Appl. No. : 09/605,282
 Filed : June 28, 2000

Changes to the Drawings

DECORATIVE ALERT SYSTEM

FIG. 1

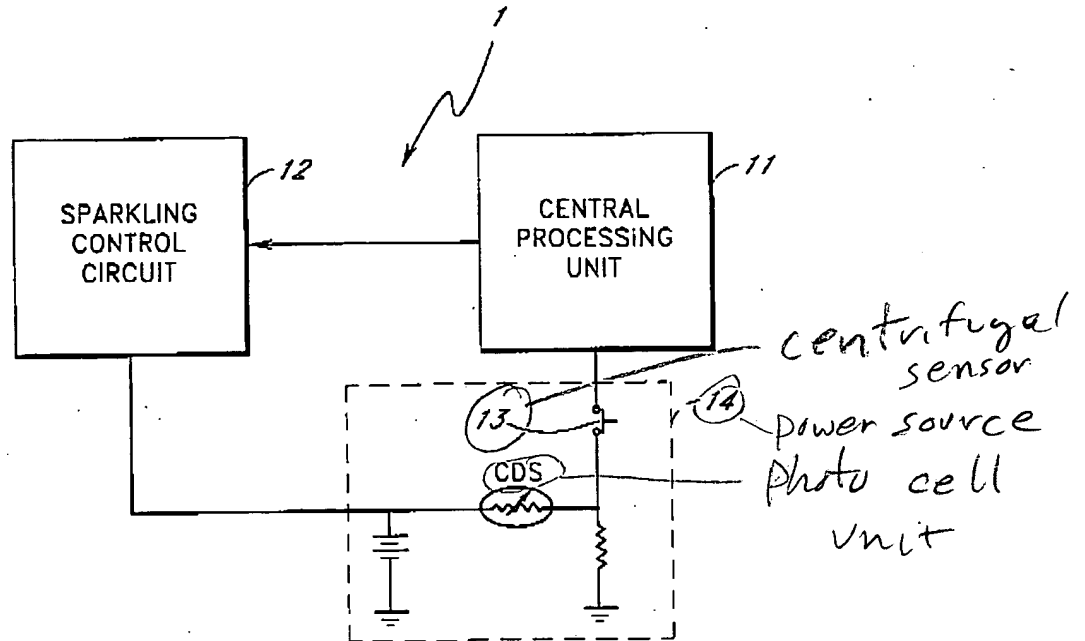
Applicant has amended Figure 1 to delete the words "Power Source" under reference numeral 14. No new matter has been added, as the specification already identifies reference numeral 14 with a power source. See Page 4, line 8.

FIG. 2

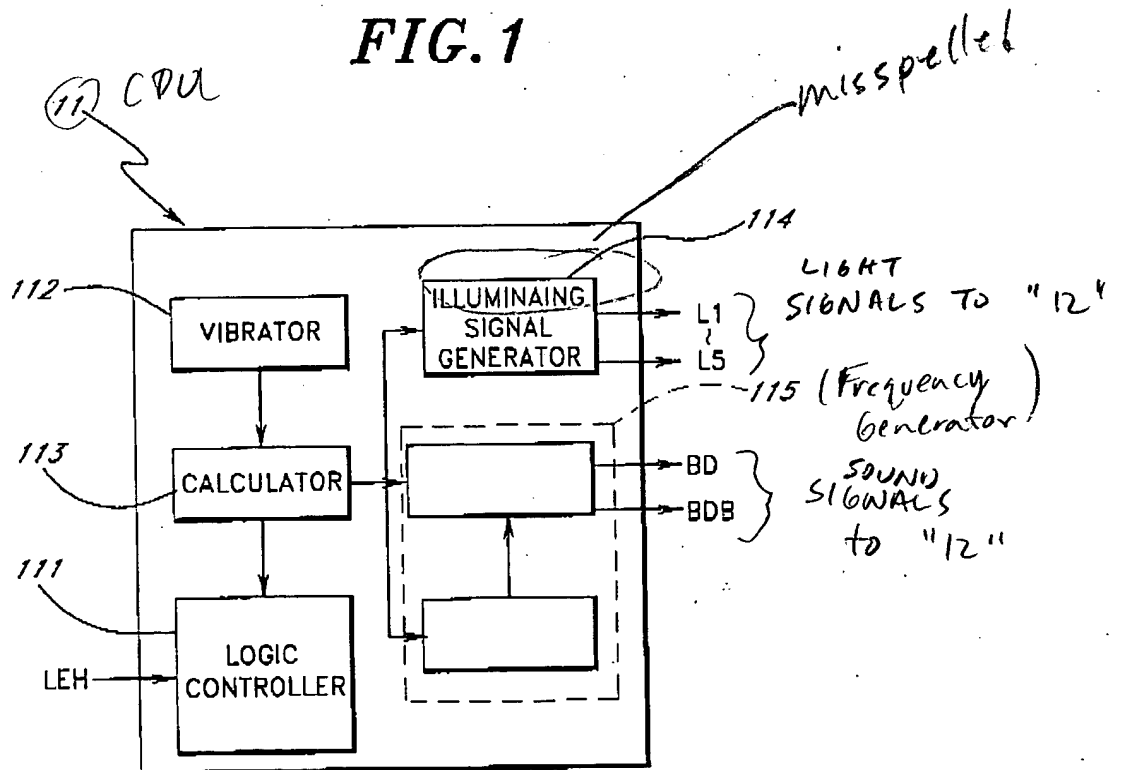
The Examiner also objected to the drawings under 37 C.F.R. § 1.84(p)(5) for not including "the following reference sign(s) mentioned in the description: a) no 'LED' shown in Fig. 2 as set forth in line 29, page 4; b) no centrifugal sensor '13' shown in Fig. 5 as set forth in line 13, page 5; c) Figs 6 and 7 show sparkling lights 'L1 to L5' and not 'L1 to L2' as set forth in line 25, page 5; d) there is no mounting groove '22' shown in Fig. 6 as set forth in line 31, page 5."

In addition, the Examiner noted that "one box shown in Fig. 2 is blank without labeling or a reference numeral" and requested clarification of the purpose of this box.

Applicant has amended Figure 2 to correctly direct the lead line of reference numeral 115 to the dashed box. Applicant respectfully submits that said lead line was inadvertently and

mistakenly directed to one of the boxes inside the dashed box and that the corrected configuration does not introduce new matter. For example, the same figure in Taiwanese Application No. 88218182, a certified translation of which is included herewith and from which the above-identified application claims priority, illustrates the correct configuration of Figure 2. Thus, the changed lead line correctly associates the dashed box with the "frequency generator" identified as reference numeral 115 in the specification. Accordingly, Applicant has deleted the words "Frequency Generator" from Figure 2. Applicant respectfully submits the two boxes within the dashed box are parts of the frequency generator and function as I/O, or input/output, modules. This is supported by the specification, for example on page 4, lines 28-32, which describes the logic controller 111 as driving the frequency generator 115 and the generator 115 communicating a signal to the sparkling control circuit 12.

Applicant has also amended the specification to replace "LED" with "LEH" on page 4, line 29. As above, this amendment merely corrects a typographical error, is supported by the specification, and does not introduce new matter. For example, lines 3 to 12 of page 5 associate "LEH" with the "high position signal," as used on page 4, line 28.

FIG. 5

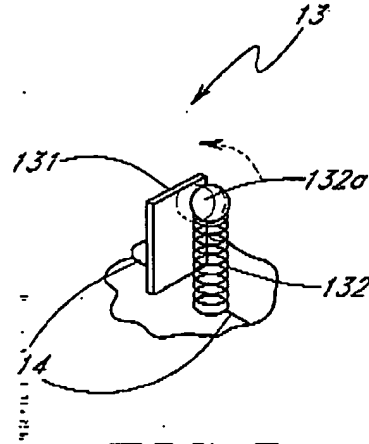
Applicant has also amended Figure 5 to include reference numeral "13" to identify the centrifugal sensor, as described in page 5, line 13 of the specification.

FIG. 6

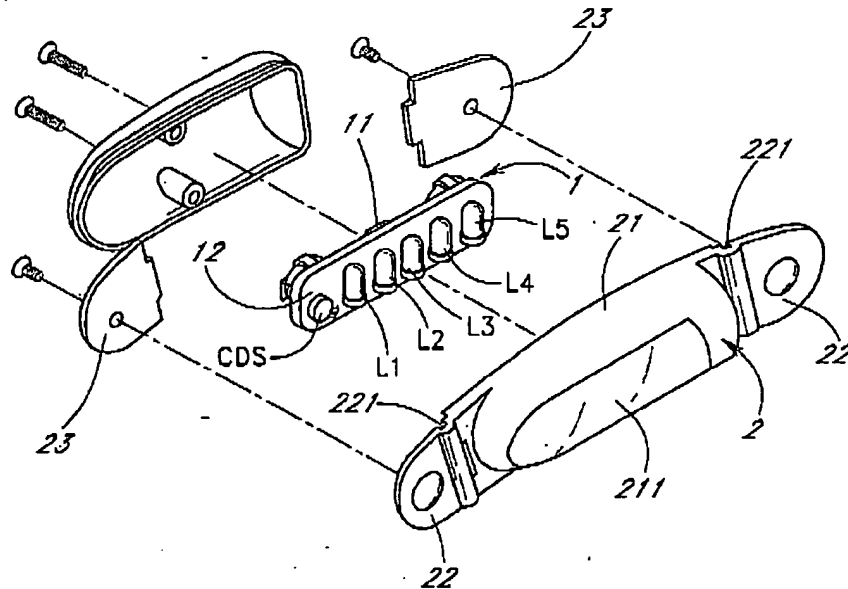
respectfully submits that these amendments merely correct typographical errors, are supported by the specification, and do not introduce new matter. For example, lines 8-12 of page 5 associate the illuminators with descriptors "L1 to L5" and Figure 6 shows five distinct illuminators labeled L1 to L5. Also, line 27 of page 5 identifies "a mounting groove" with reference numeral 221, and Figure 6 identifies grooves with reference numeral 221.

Applicant has also amended the specification to replace "L1 to L2" with "L1 to L5" on page 5, line 25 and to replace "groove 22" with "groove 221" on page 5, line 31. Applicant
